Technical Bulletin 169

2016

Contents

Description: Front Brake Lever

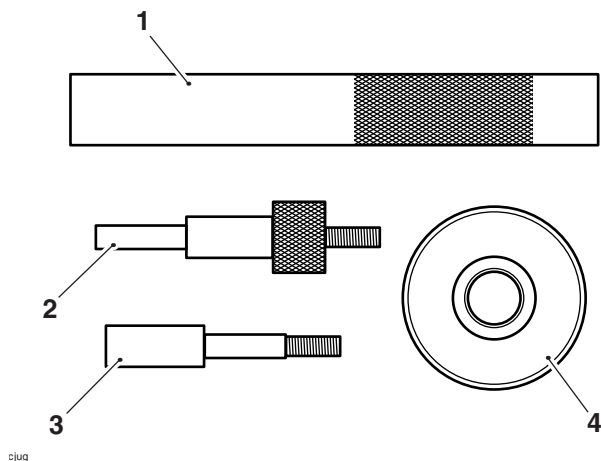
Brembo brake levers for radial master cylinders will no longer be supplied as a complete assembly.

The lever is now supplied without the pivot and push rod. If for any reason the pivot or push rod requires replacing the master cylinder must be replaced. This is because the push rod is adjusted to the master cylinder it is fitted to during manufacture.

A service tool part number T3880636 has been released to remove and refit the front brake lever pivot sleeve on motorcycles fitted with Brembo front brake levers.

Description: Rear Brake Hose

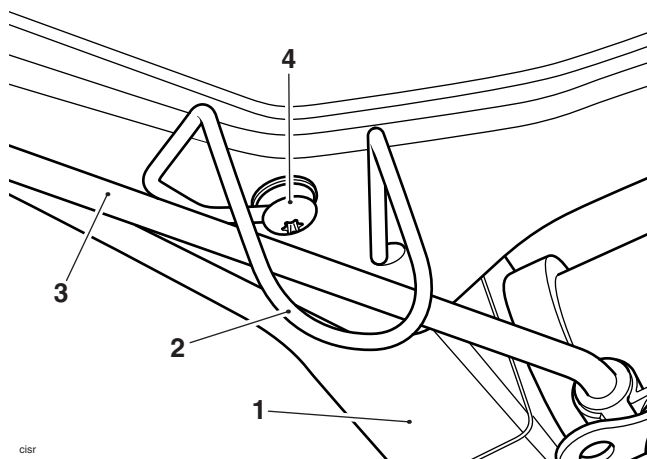
A revised rear brake hose with the addition of a wire guide has been introduced to the Thunderbird Commander and Thunderbird LT models from VIN 764829. The revised brake hose is 32mm longer in length and is fitted in conjunction with a wire guide on the swinging arm. The new brake hose is not retrofittable. A new swinging arm has been introduced to cater for the new wire guide and is retrofittable to all above models.

- The procedure for the assembly and removal of the brake hose is detailed in the Service Manual with the exception of the wire guide and associated fixing. These are detailed in the illustration below.
- The wire guide is fitted to the underside of the swinging arm. The fixing on the wire guide is encapsulated, and must be replaced if loosened or removed. Tighten the fixing to 5 Nm.

Description: Engine Oil Dipstick Upper and Lower Level Marking

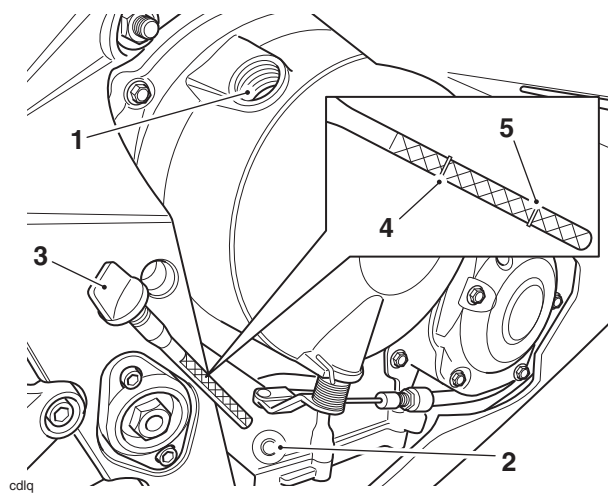
A new engine oil dipstick has been introduced to the above models from engine number 667833 and is retrofittable. Parts will no longer support the old condition engine oil dipstick and any replacements supplied will be the new condition.

Note the position of the upper and lower markings on the new dipstick.

Description: Crankcase Ground, Stud and Locknut

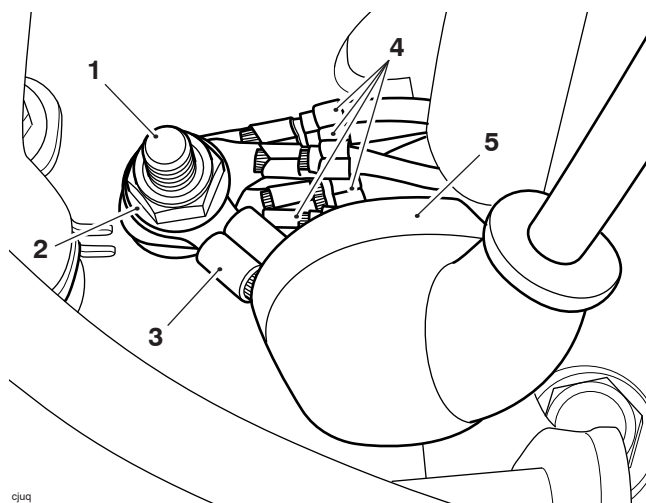
The battery and wiring harness ground terminals are secured to the upper crankcase using a pre-encapsulated stud and locknut.

If for any reason the locknut and or stud are removed they must be replaced.

Tighten the stud to **4 Nm** and the locknut to **10 Nm**.

Description: Sidestand Switch Cable Guide Fixing

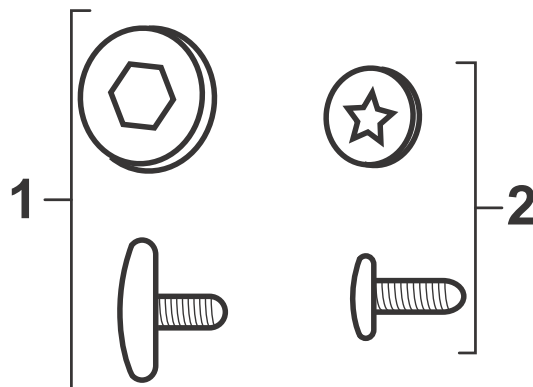
The sidestand sensor cable guide to the frame fixing has changed to a M5 x 12 mm Torx head from VIN 756873. The Torx head fixing is retrofittable as a direct replacement to the button head fixing used on earlier models.

1. Fixing M5 x 8 mm - up to VIN 756872

2. Fixing M5 x 12 mm - from VIN 756873

If removed for any reason the Torx head fixing must be tightened to **3 Nm**.

Description: Gearchange Lever Fixing

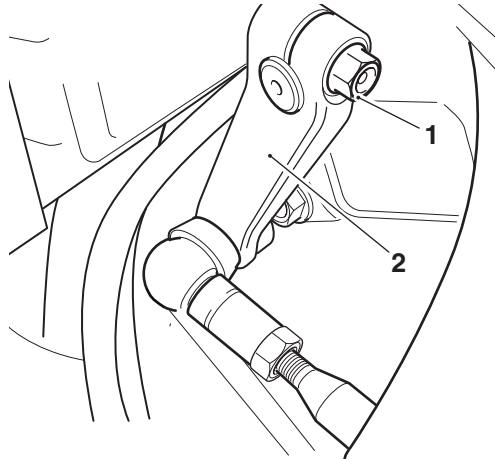
The torque figure has changed. If loosened or removed for any reason the fixing(s) must be torqued as required.

Tighten the fixings to **9 Nm**.

Item: 169.10
Description: Front Brake Reservoir Bracket
Model Affected: Thruxton 1200R

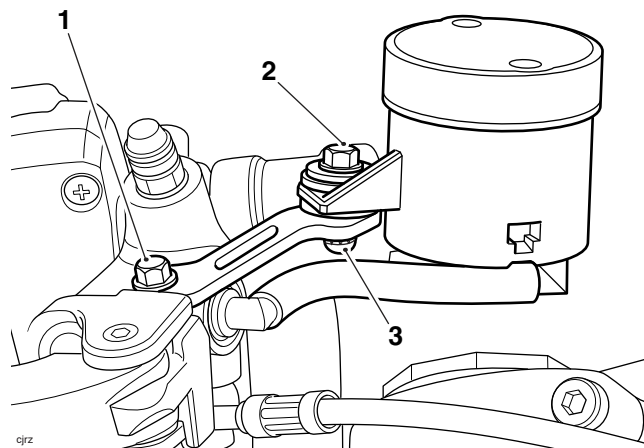
The torque figure has changed. If loosened or removed for any reason the fixing(s) must be torqued as required.

Tighten the brake master cylinder fixing to **7 Nm**.

Counter hold the brake fluid reservoir lock nut and tighten the fixing to **7 Nm**.

Item: 169.11
Description: Relay Designation
Model Affected: Tiger Sport (from VIN 750470)

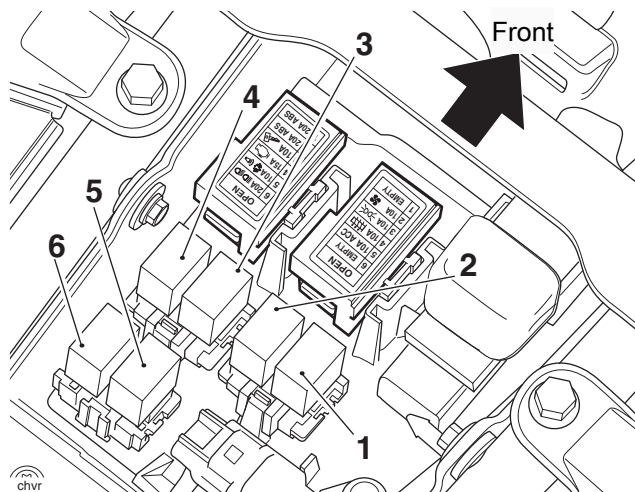
A normally open (black) relay has replaced the starter circuit changeover (blue) relay from VIN number 760417 and is retrofittable. Parts will no longer support the old condition blue relay and any replacements supplied will be the new condition.

Frame Bolts Exploded View

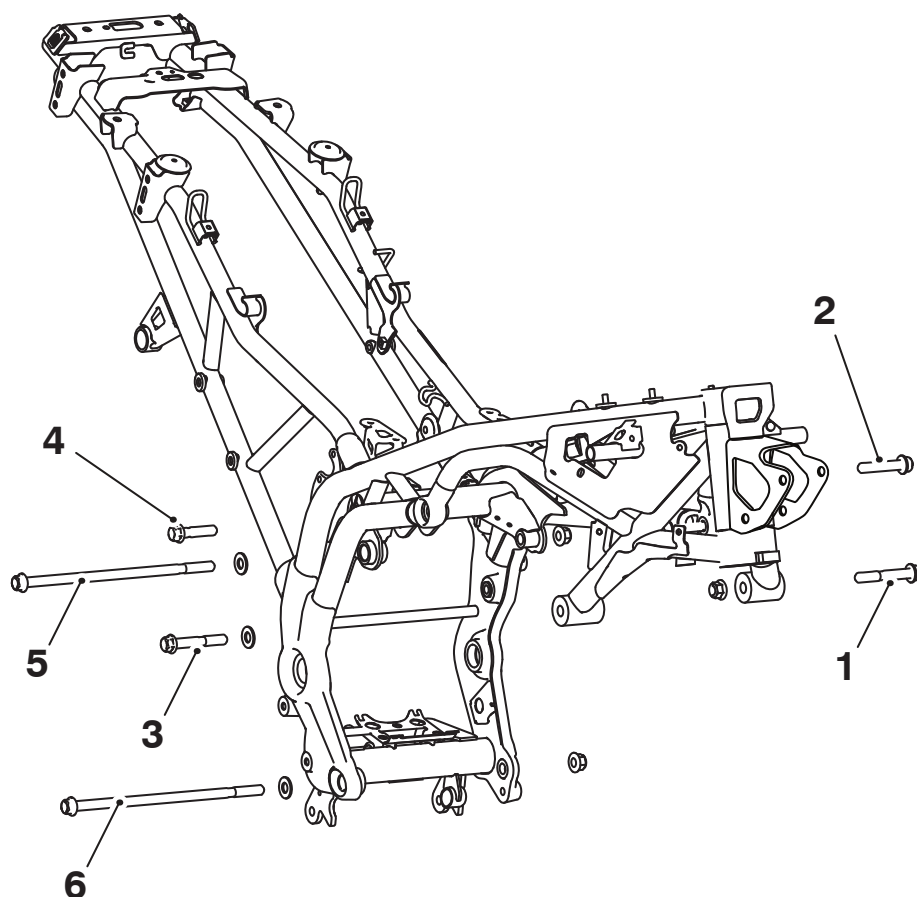
The frame bolt tightening sequence and torque figures have been updated for the above models. When refitting an engine to the above models, follow the new frame bolt tightening sequence as described in the procedure below:

Unless the following engine mounting bolt tightening sequence is precisely followed, severe frame damage can occur.

9. Fit the left hand rear cylinder head bolt. Do not fully tighten at this stage.
10. Fit a new lock nut to the left hand front cylinder head bolt and tighten to **24 Nm**.

11. Tighten the left hand rear cylinder head bolt to **85 Nm**.

12. Using service tool T3880377, tighten the three adjusters in the following sequence.
 - Tighten the lower crankcase adjuster to **5 Nm**, then remove the lower crankcase bolt and washer and refit to the right hand side of the frame.

- Tighten the upper crankcase adjuster to **5 Nm**, then remove the upper crankcase bolt and washer and refit to the right hand side of the frame.
 - Tighten the cylinder head front right hand adjuster to **3 Nm**, then remove the right hand front cylinder head bolt and washer and refit to the right hand side of its mounting.

Frame Bolts Exploded View

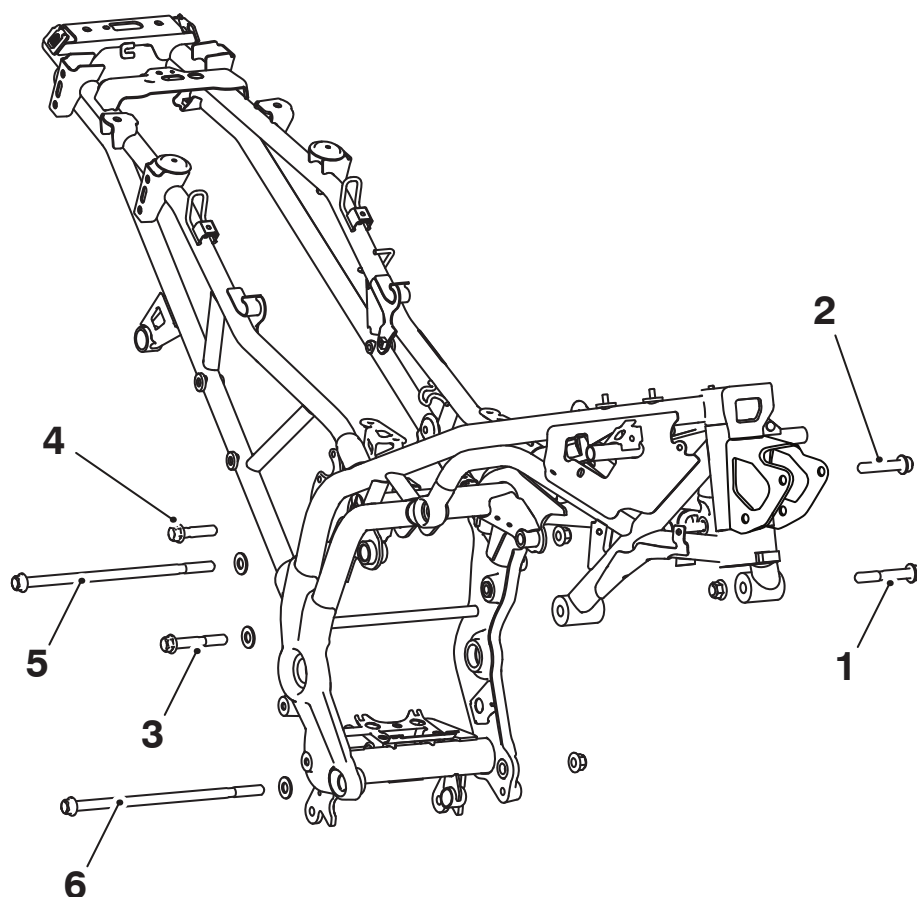
The frame bolt tightening sequence and torque figures have been updated for the above models. When refitting an engine to the above models, follow the new frame bolt tightening sequence as described in the procedure below:

Unless the following engine mounting bolt tightening sequence is precisely followed, severe frame damage can occur.

9. Fit the left hand rear cylinder head bolt. Do not fully tighten at this stage.
10. Fit a new lock nut to the left hand front cylinder head bolt and tighten to **24 Nm**.

11. Tighten the left hand rear cylinder head bolt to **85 Nm**.

12. Using service tool T3880377, tighten the three adjusters in the following sequence.
 - Tighten the lower crankcase adjuster to **5 Nm**, then remove the lower crankcase bolt and washer and refit to the right hand side of the frame.

- Tighten the upper crankcase adjuster to **5 Nm**, then remove the upper crankcase bolt and washer and refit to the right hand side of the frame.
 - Tighten the cylinder head front right hand adjuster to **3 Nm**, then remove the right hand front cylinder head bolt and washer and refit to the right hand side of its mounting.
